West Side Fine Screens Building

Change Order 070 – Revising Junction Chambers for Overflow Conditions

Masonry Removal for Change Order - 081, April 2017

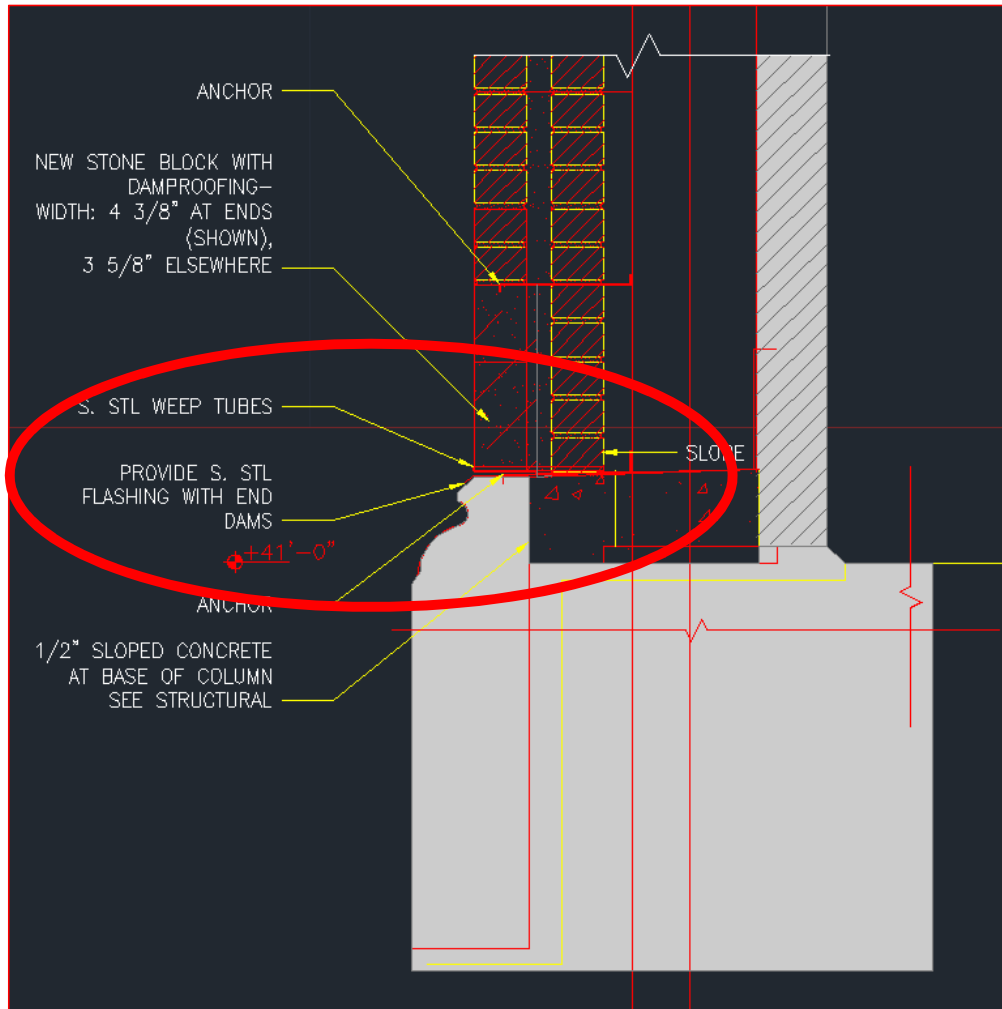
The Screen Building has 32 steel columns on the exterior walls. Masonry must be removed from each pilaster to inspect the column behind.

- If the inspection indicates the column is in good condition, it will be cleaned and painted to prevent corrosion and the brick replaced.
- If the column requires repair, it will be cleaned, reinforced with new steel, painted, and the brick replaced.

The 32 columns are each approximately 20' tall. Each column will have to be exposed for its entire height in order to determine the complete scope of column repair work. This will require a significant amount of masonry removal, weather protection, and bracing to stabilize the masonry walls, glass block windows, and roof.

The existing spandrel beams and columns became severely corroded because the original masonry construction did not allow a pathway for water infiltration to escape. The beams and columns were completely encapsulated in masonry which trapped moisture on to the steel surfaces, causing it to corrode. After the masonry is removed for this change order, new masonry will be installed with masonry ties which will leave open space around the beams and columns. Water infiltration will flow through this open space and will be directed out of the wall cavity by stainless steel flashing and weep holes. Therefore, the beams and columns will no longer be in such a corrosive environment

Original JC #8 Design

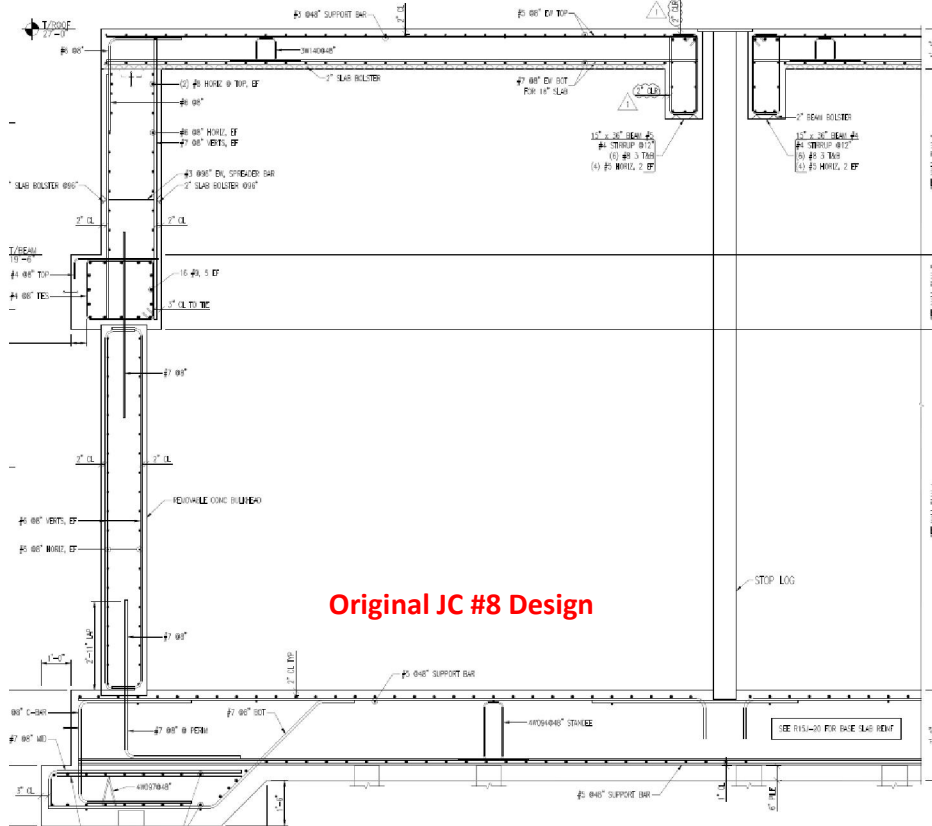
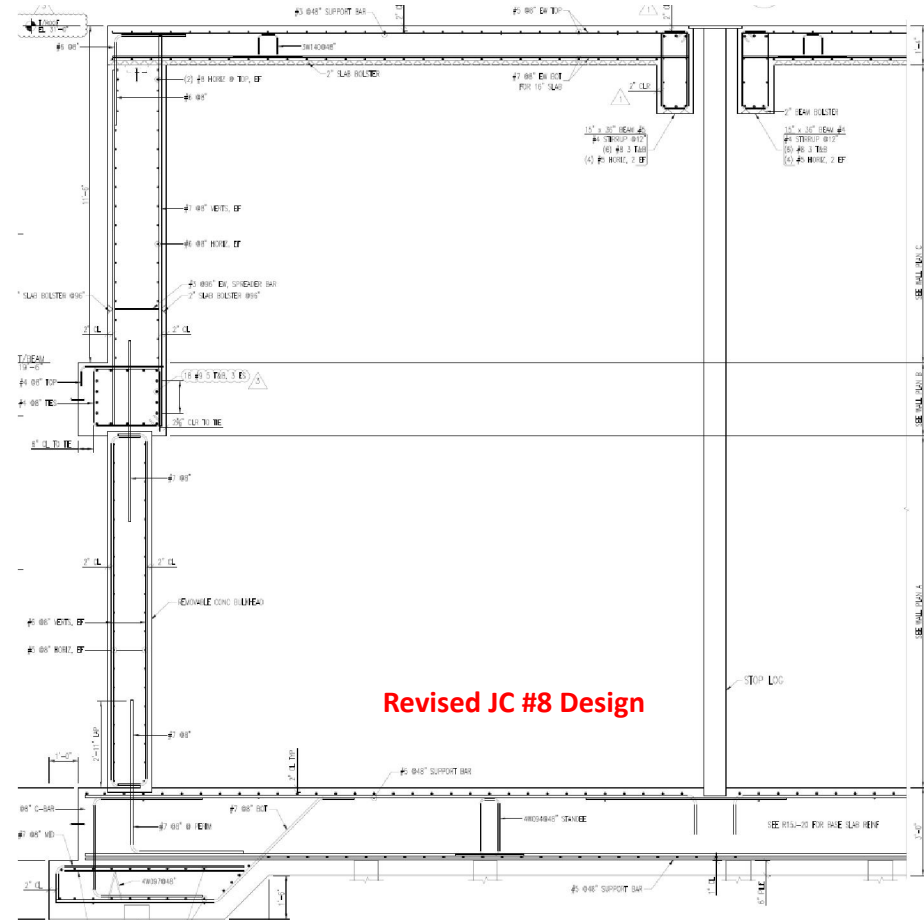
When designing the Junction Chambers, the top elevation of the roof slabs of the chambers was based on normal operating conditions. However, under very high-flow conditions, the District restricts flow from the Westside plant to the Southwest plant. Under this condition, sewage water elevations will be higher than normal conditions and will overflow Junction Chambers 1,4,5,6, & 8. Therefore, the elevations of these chambers must be raised.

Change Order 070 – Raising Elevation of Junction Chambers

For Junction Chamber 8, it is required to increase the height of the two-foot thick reinforced concrete walls and the stop logs by 4'. For the other JC's, the precast barrel sections on top of the roof slabs will be replaced by a water tight cast in place concrete barrel section with dowels and hydrophilic waterstops.
